Sewerage Impact Assessment Report
with Response-to-Comment

Section 12A Rezoning Application for Proposed Columbarium on Various Lots in D.D.41, Sha Tau Kok, New Territories

Sewerage Impact Assessment Report

Reference: P036/03 Issue 3

Figures

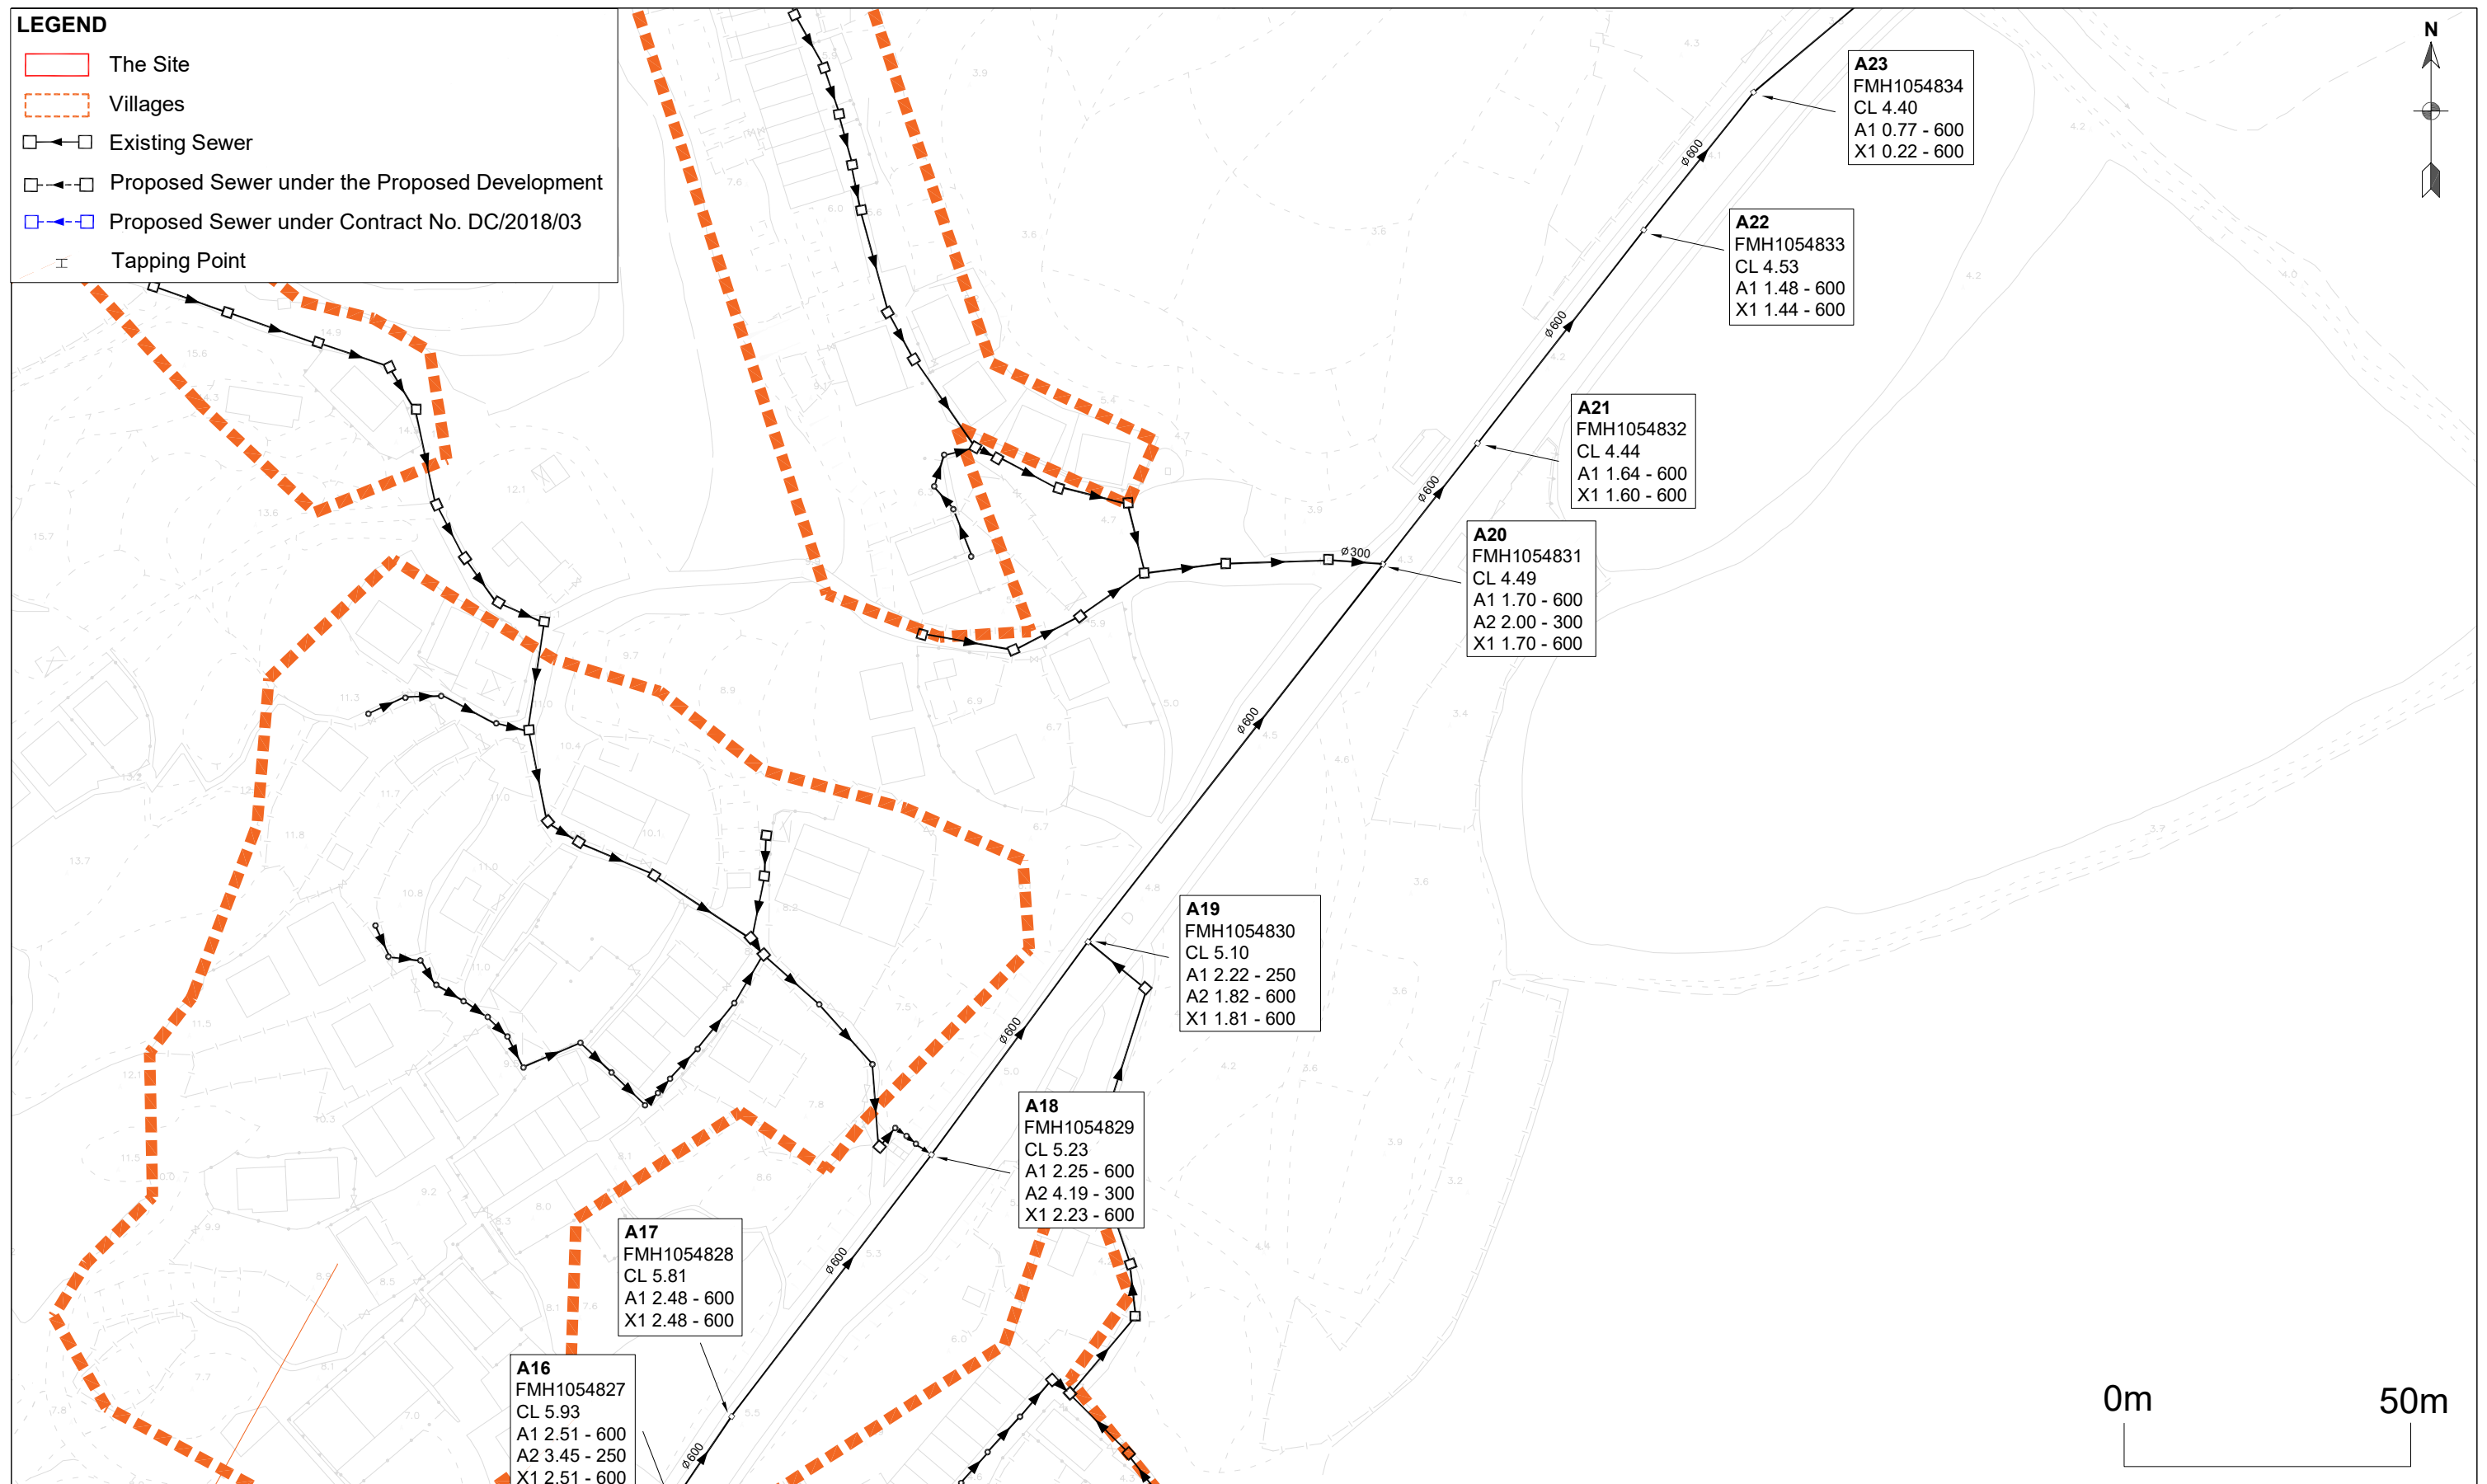
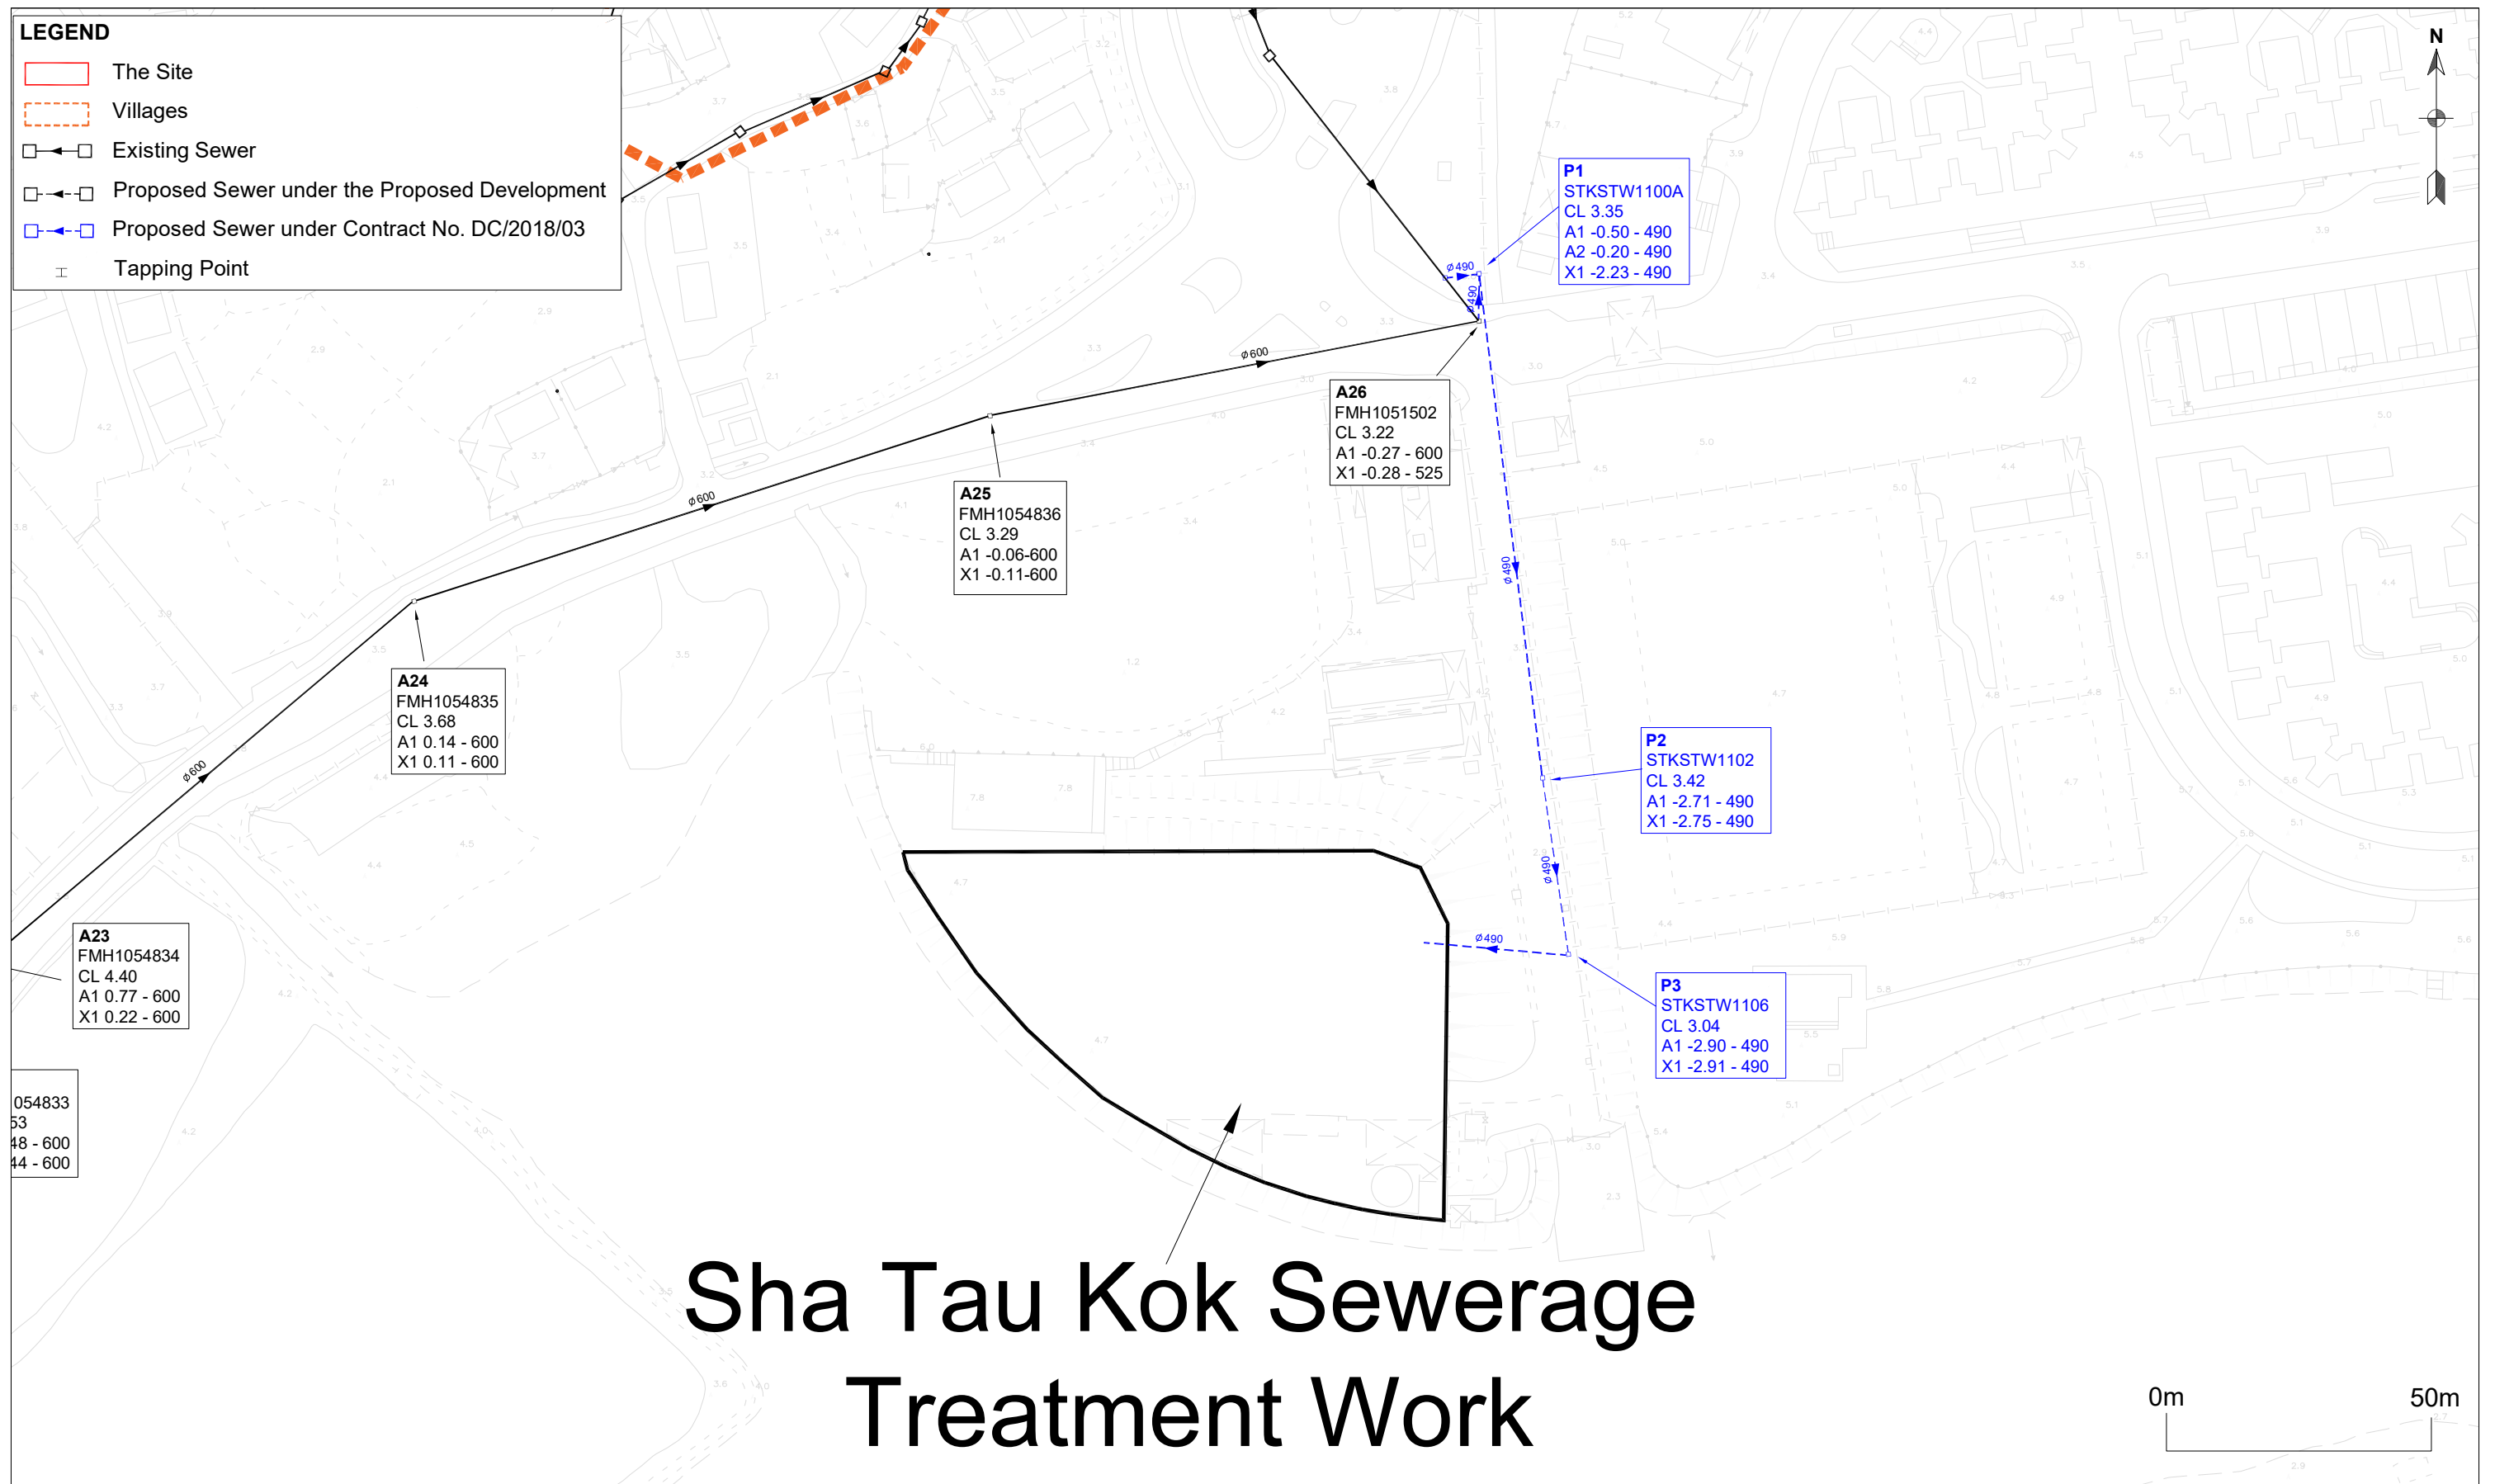
Items	Comments	Response
Comments on Sewerage Impact Assessment from DSD		
a	This SIA report needs to meet the satisfaction of EPD, the planning authority of sewerage infrastructure.	Noted.
b	The applicant should check and ensure that the existing sewerage system to which the proposed connection will be made have adequate capacity and satisfactory condition to cater for the additional discharge from the site. He should also ensure that the flow from this site will not overload the existing sewerage system.	Noted.
c	Figure 3.1 should show the alignment of all existing public sewerage network in the vicinity of the site. The applicant should ensure that a 3m clear distance between the proposed structure and the existing public sewerage network would be maintained.	Noted. Figure 3.1 shows the alignment of existing public sewerage networks along Sha Tau Kok – Shek Chung Au. It is confirmed that a distance of more than 3m between the proposed structure and the existing public sewerage network is maintained. Please refer to Figure 3.1.

d	Consideration should be given to adopt polyethylene (PE100) pipe for buried sewage pipe beyond the sewage terminal manhole.	Noted. Polyethylene (PE100) pipe will be adopted.
e	The location of the terminal manhole shall be designed and constructed close to the lot boundary as far as practicable.	Noted and revised. The location of the terminal manhole has been designed to be as close to the lot boundary as possible. Please refer to Figure 3.1.

Comments on Sewerage Impact Assessment from DSD		
1	Figure 3.1 has not shown the alignment of all existing public sewerage network in the vicinity of the site (e.g. the sewerage system at Tong To). The applicant should review.	Noted and updated. Please refer to Figure 3.1.
2	RtoC item h: Please update section 5 regarding the handover arrangement of sewerage pipe to DSD. Please note that DSD would only consider taking up the maintenance of connection pipe located downstream of the terminal manhole and outside the private lot boundaries after satisfactory technical audit by DSD. The applicant should be responsible for the maintenance of pipes constructed under this development which have not been handed-over to other parties for maintenance.	Noted and revised. Please refer to Section 5.
3	Unless the applicant can submit satisfactory DIA and SIA reports, I do not support the application.	Noted.
